MINERALS PROGRAM INSPECTION REPORT

MINE NAME: West Farm Pit	MINE/PROSPECTING ID#: M-2008-078	MINERAL: Gravel and sand	COUNTY: Prowers
INSPECTION TYPE: Preoperation Inspection	INSPECTOR(S): Amy Eschberger	INSP. DATE: November 29, 2018	INSP. TIME: 13:30
OPERATOR: Prowers Aggregate Operators, LLC	OPERATOR REPRESENTATIVE: Roy Cue	TYPE OF OPERATION: 112c - Construction Regular Operation	
REASON FOR INSPECTION: Preoperation Inspection	BOND CALCULATION TYPE: Complete Bond	BOND AMOUNT: \$575,000.00	
DATE OF COMPLAINT: NA	POST INSP. CONTACTS: None	JOINT INSP. AGENCY: None	
WEATHER: Clear	INSPECTOR'S SIGNATURE: 	SIGNATURE DATE: January 25, 2019

This was a pre-operation inspection of the West Farm Pit (Permit No. M-2008-078) conducted by Amy Eschberger of the Division of Reclamation, Mining and Safety (Division) in response to the Amendment application (Revision No. AM-1) filed for the site on November 5, 2018. The public comment period for AM-1 closed on December 26, 2018. The Division received two timely comments on AM-1, including an objection from the City of Lamar expressing concerns about their existing sewer lagoons and monitoring wells located within 200 feet of the northern permit

Photo 25. View looking east across proposed permit area west of main access road and south of wash plant, where a conveyor may be installed in the future.

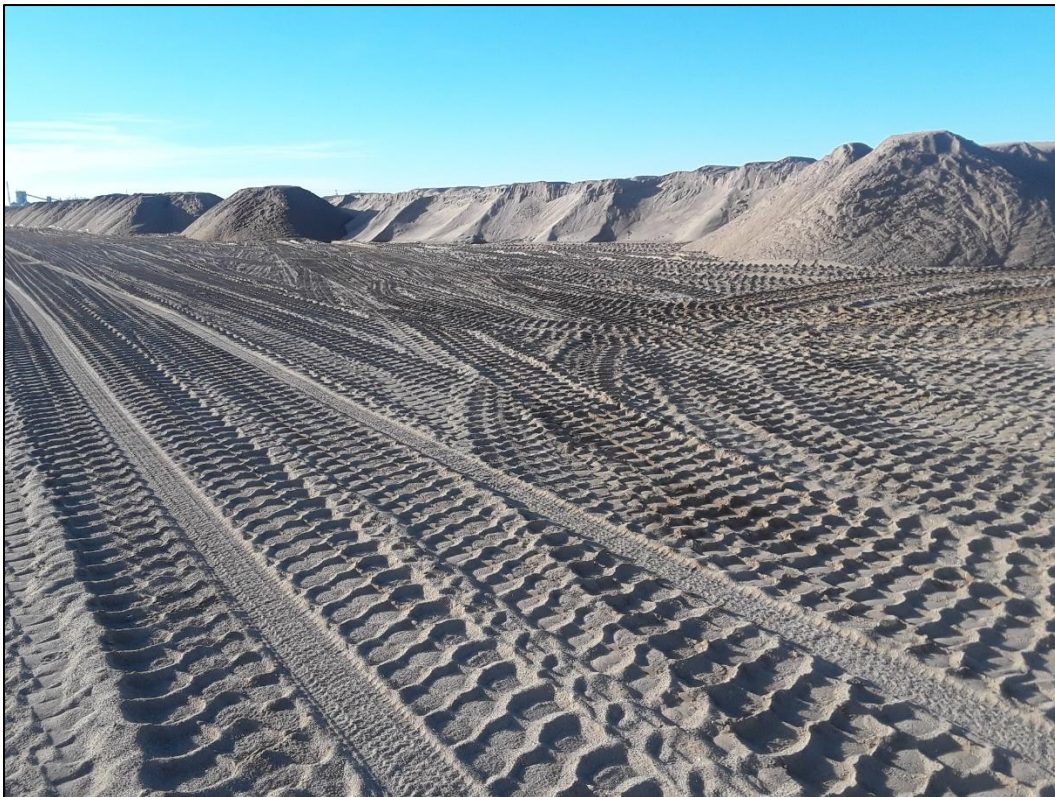
The Division observed the field located west of the scale house, where AM-1 initially discussed plans to construct a conveyor for transporting product from the wash plant south to the load-out area near the railroad (**Photo 25**). AM-1 has since then removed plans for constructing the conveyor and commits to submitting a permit revision with more details on the conveyor and a revised reclamation cost estimate prior to its construction. No other uses of this area have been proposed by AM-1.
